Addendum No. 4R ITB #6498

Interior Renovations and Classroom Addition for Lake Ridge Elementary

ADDENDUM #04R

INTERIOR RENOVATIONS & CLASSROOM ADDITION FOR: LAKE RIDGE ELEMENTARY SCHOOL

A102A

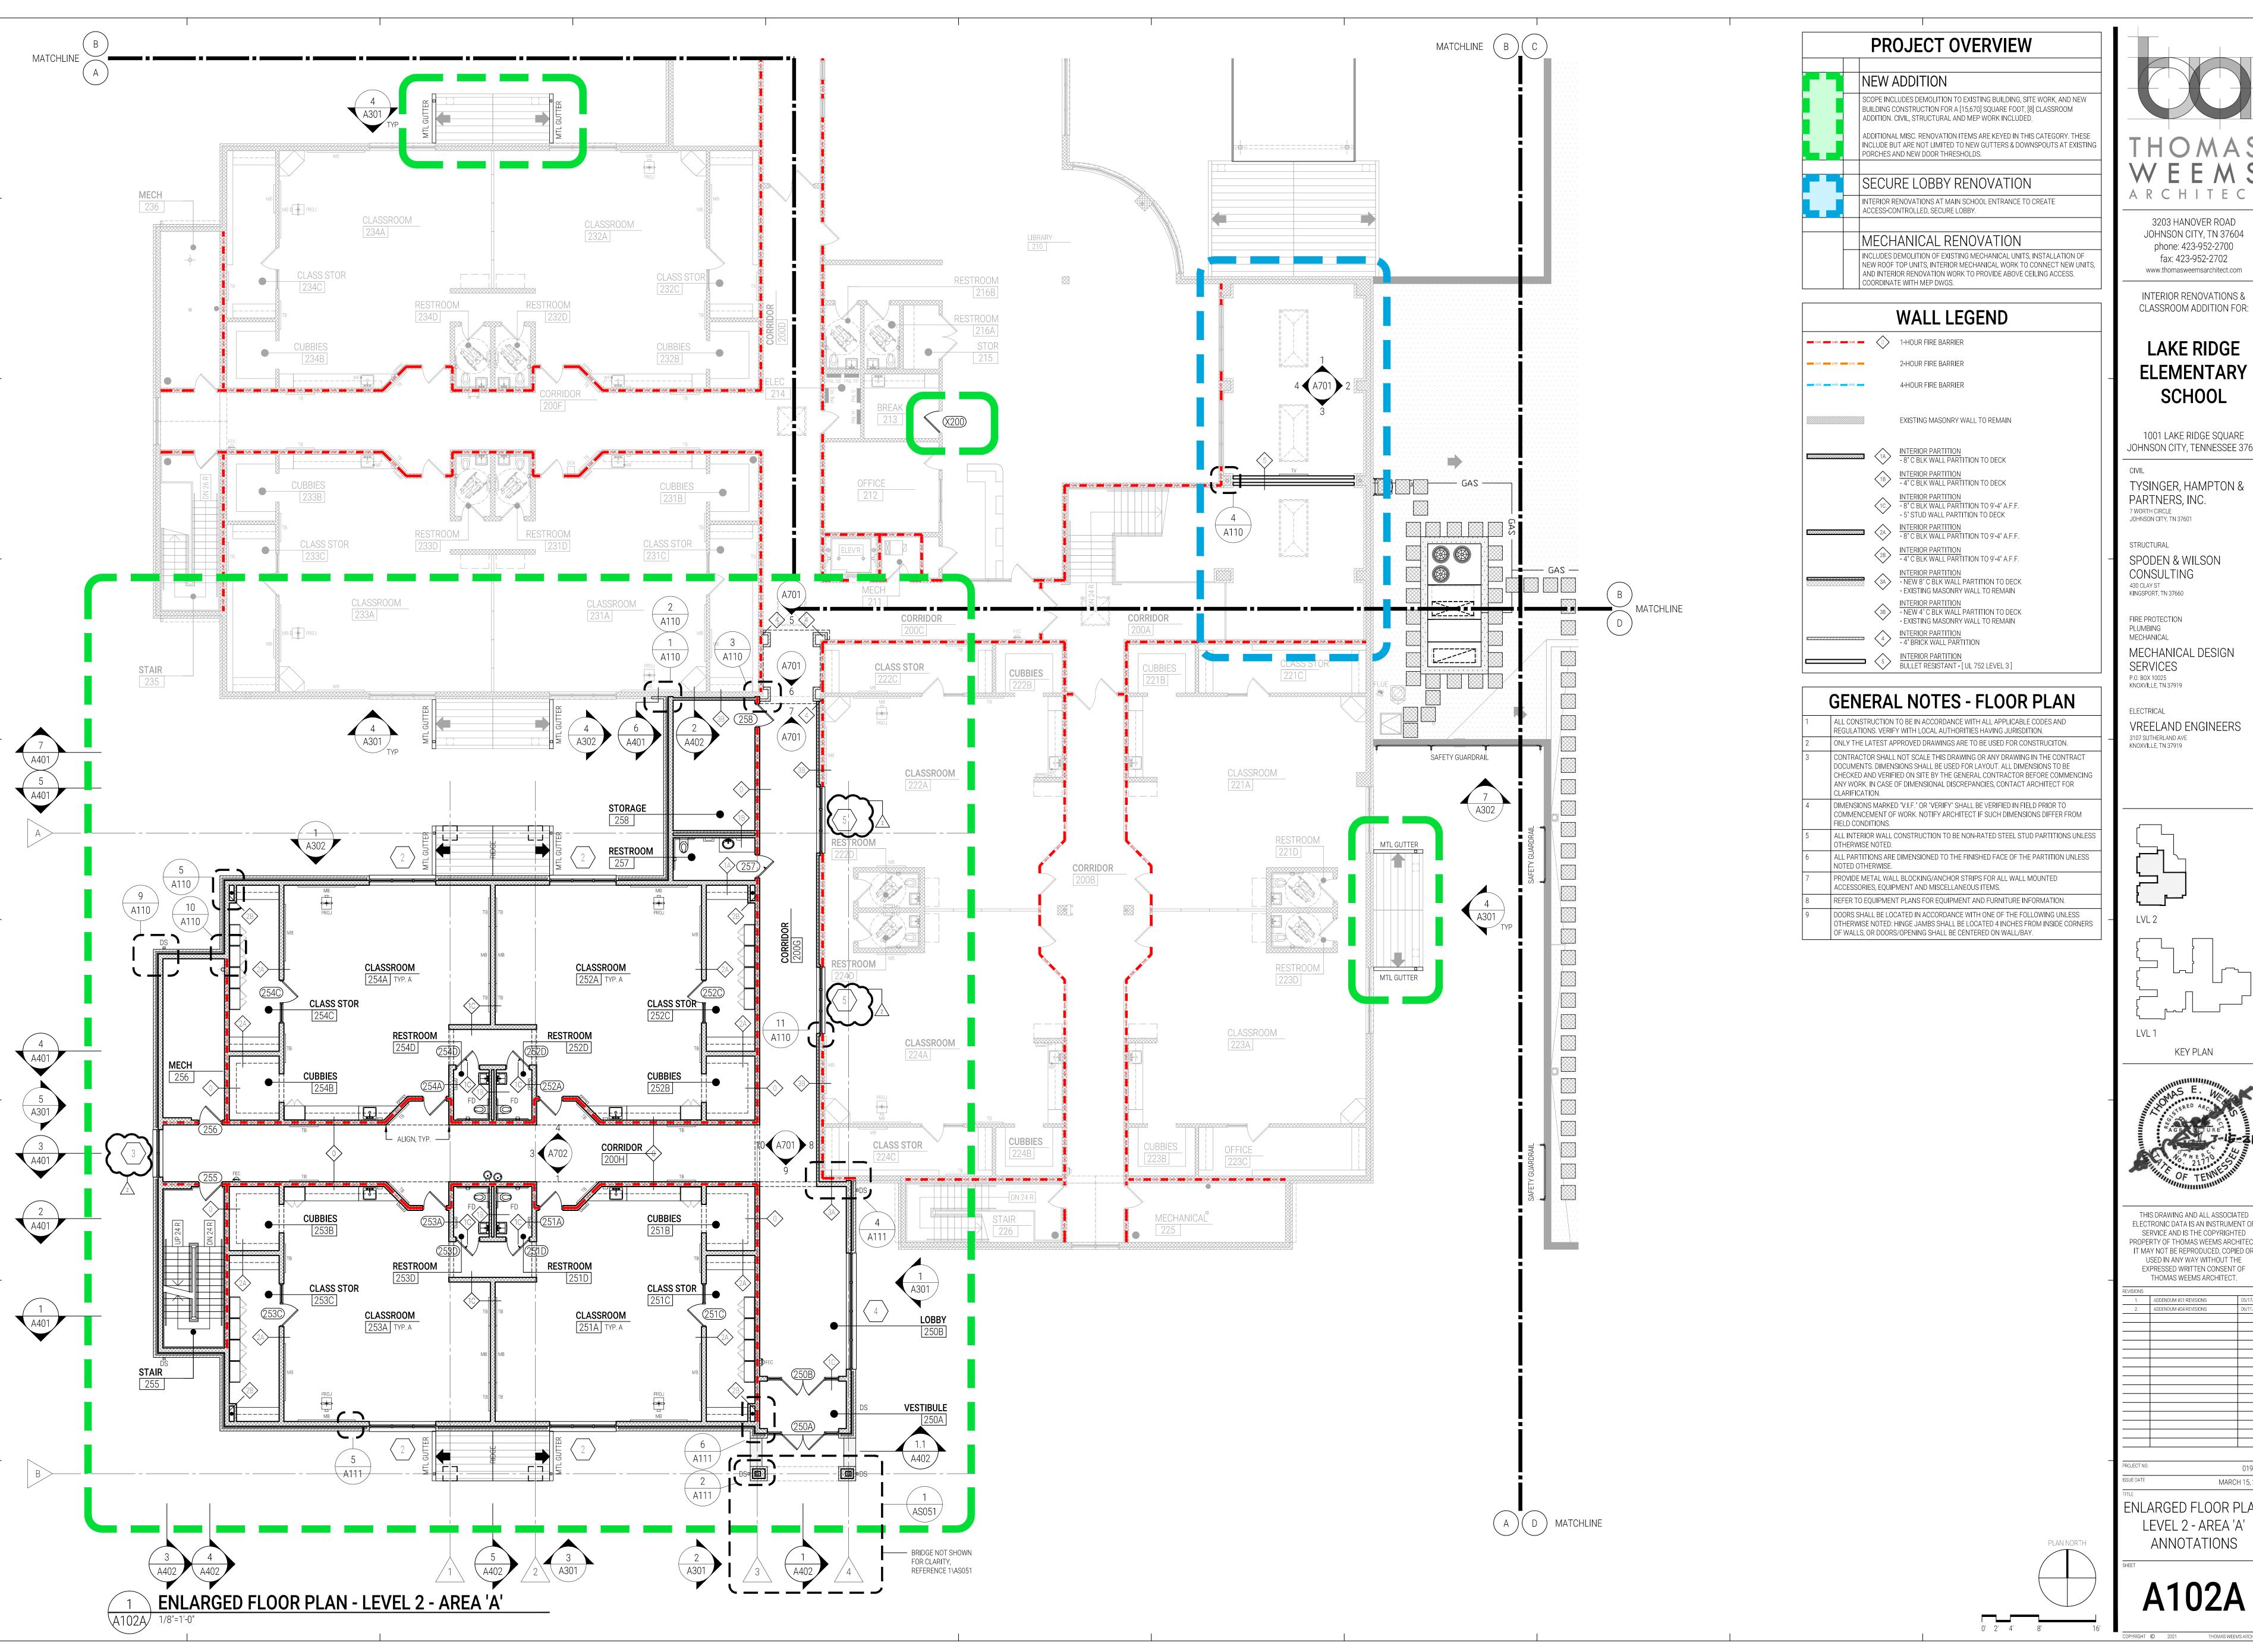
- 1. Insert revised A102A Enlarged Floor Plan Level 2 Area 'A' Annotations:
 - a. Revised window type in Classroom 222A and 224A from Type 3 to Type 5.
 - b. Revised window type in Corridor 200H from Type 5 to Type 3.
